Name: Micaela's Village – 2694 Unaweep Ave - Final Plan

REVIEW COMMENTS FOR: Micaela's Village #135-94(2)  
TYPE OF REVIEW: Final Plan & Plat  
REVIEWED BY: Jody Kliska

**Response to review comments for:** Micaela's Village #135-94(2)  
**Type of review:** Final Plan & Plat  
**Response by:** Terry Nichols

Figure 1: Major Basin and Existing Flow Conditions

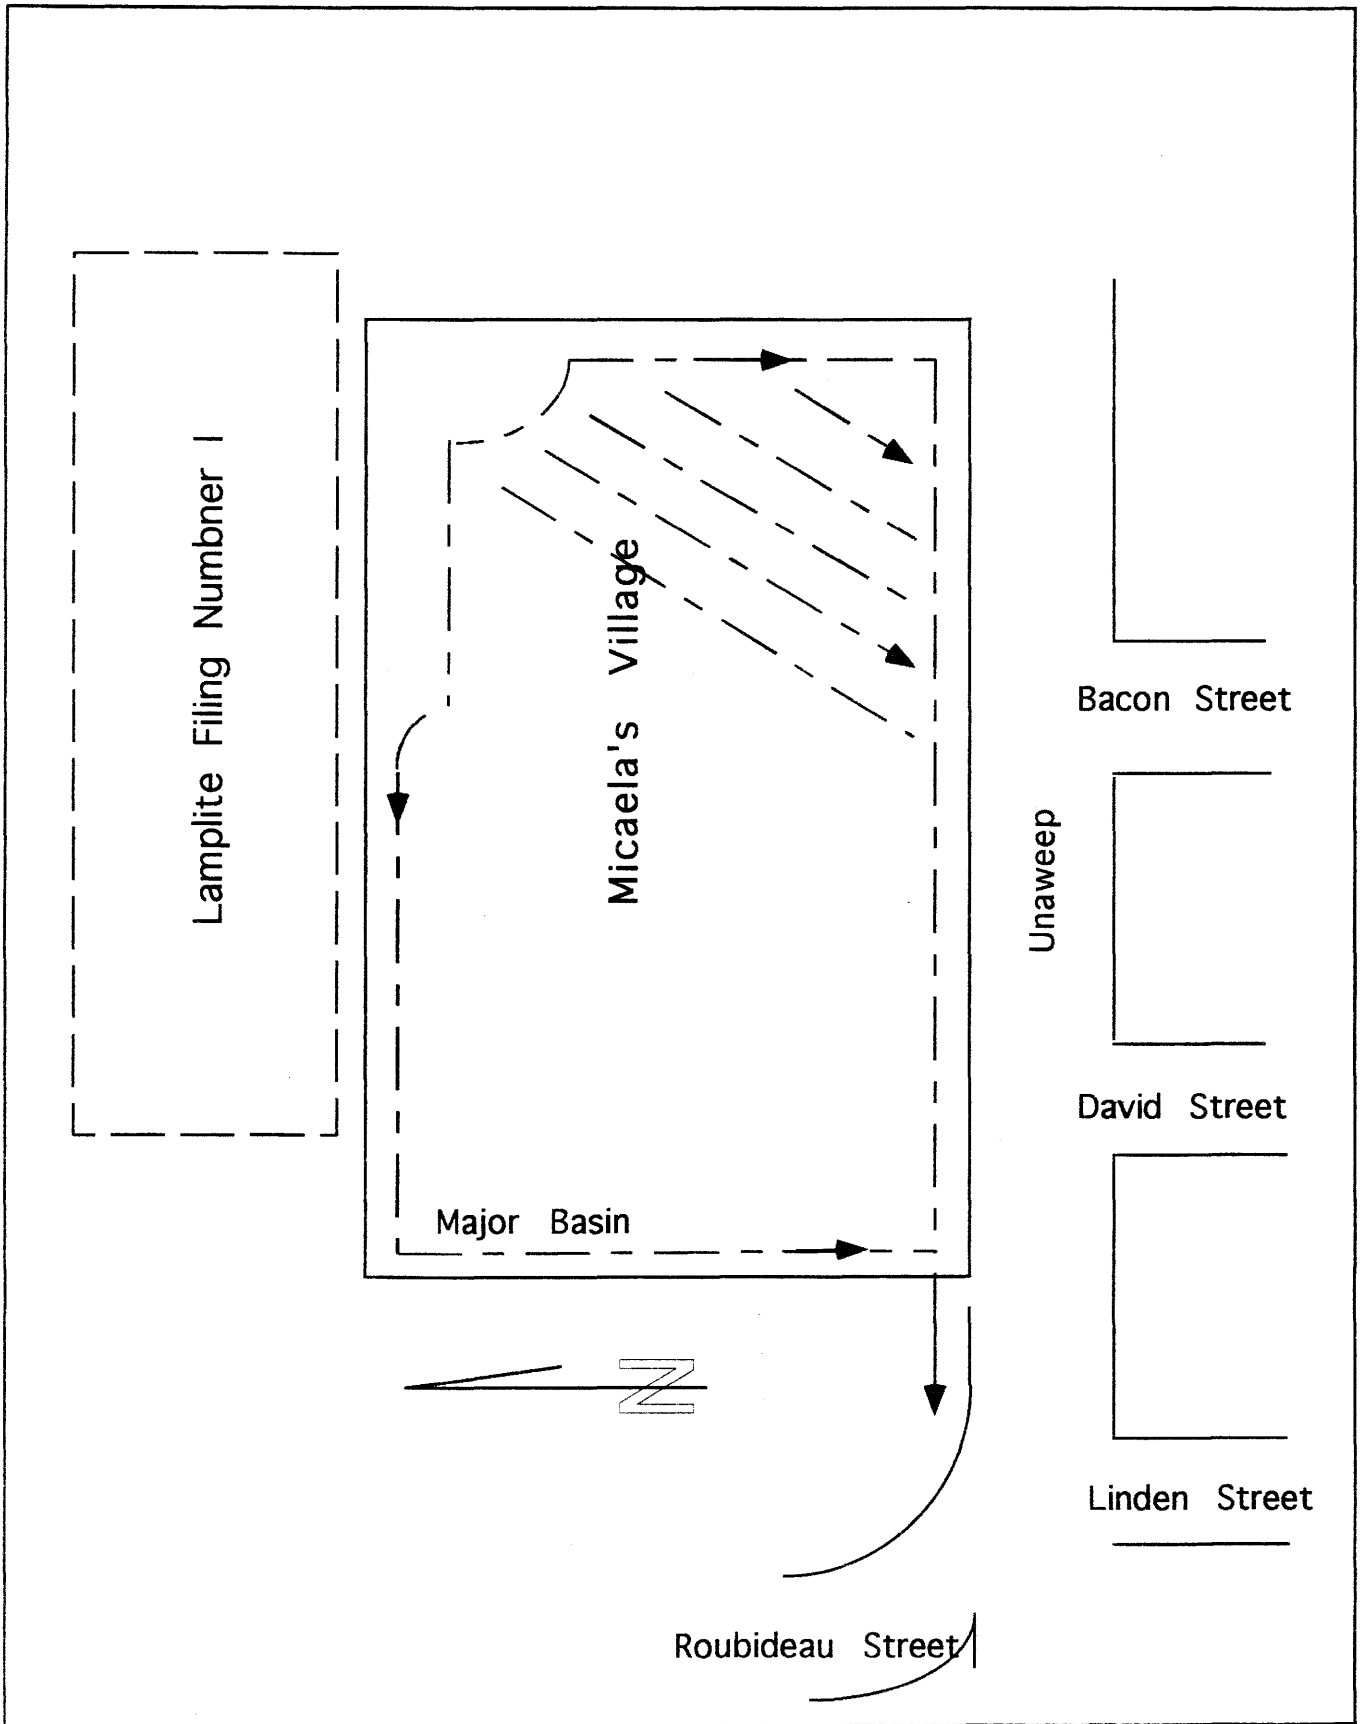
Development of the property will result in an increased peak discharge and decreased time of concentration. The present conveyance system is inadequate to transport the historical two year event. The proposed drainage plan is to route all stormwater in the property directly to the Colorado River without detention.

Nihols Associates engineers Terry Nichols and Eric Marquez meet with City Engineers Don Newton and Jody Kliska on 22 Mar-95 to discuss drainage for this project. It was decided that the drainage should be piped under Santa Clara to an existing surface channel extending to the Colorado river. This routing was previously approved. The City will provide a new

inlet grate and box to replace the existing box. The developer will provide other improvements to the existing drainage channel.
